Roy F. Weston, Inc.
Suite 500
750 East Bunker Court
Vernon Hills, IL 60061-1450
847-918-4000 • Fax 847-918-4055
www.rfweston.com

TDD: 0105-004
Document Control No.: 103-3A-ABFM

Re: Review Comments on the Removal Action Work Plan
The Lockformer Company, Lisle, Illinois

FIGURE 4.3-1

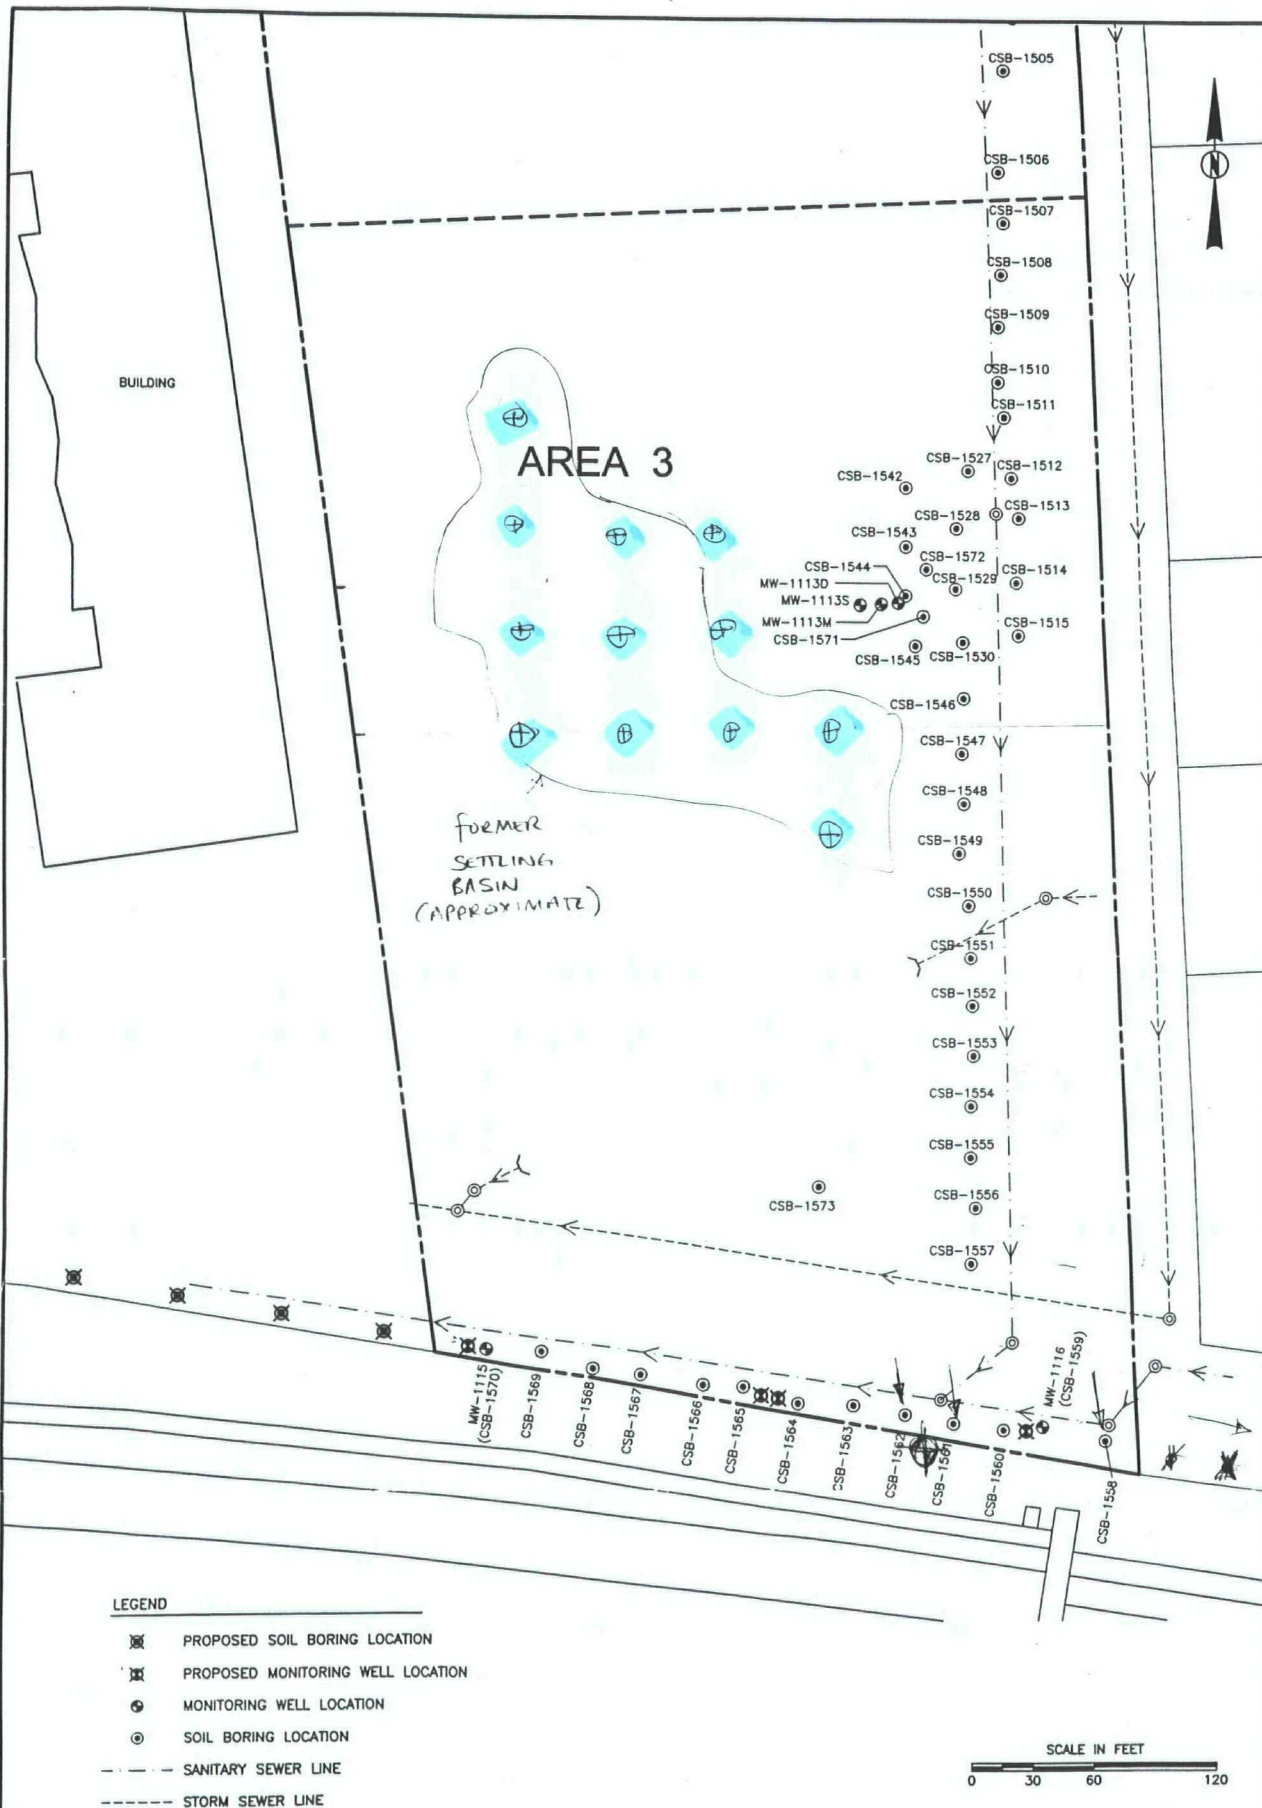
1. Although the first sentence of the first paragraph indicates that sampling will occur to the east of the Lockformer facility, Figure 4.3-1 does not indicate sampling locations east of the facility. Figure 4.3-1 should be revised to include the proposed boring locations east of the facility and should also include unique location identifiers for all proposed borings and wells.

4. Lateral migration of TCE may have occurred within the southern portion of Area 3. WESTON recommends collection of additional samples north and south of the existing line of borings to confirm that lateral migration has not occurred. Recommended boring locations are indicated on **Figure 4.3-1 of Attachment A**. The traverse of borings north of the sanitary
